Re: Initial & Final Planned Development (PCD) for Black Hills Corporation 7001 S Highway 16 – Comments Review

Re: Initial & Final Planned Development (PCD) for Black Hills Corporation 7001 S Highway 16

# EXAMPLE OF SEGMENTED BLOCK WALL

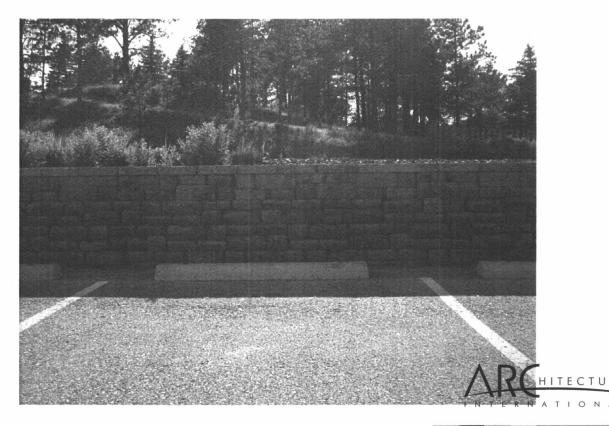
- 4. City staff commented on needing additional information about fence around Child Care area. The fence located around the Child Care play area will be a 42" high segmented block wall. The segmented retaining wall will be worked into the site

- grades and will range from 0" to 42" above grade. Additional landscape will be installed around the play area to help screen the play area and retaining wall. See attached photos for examples of similar retaining wall conditions that will be located around the Child Care area.
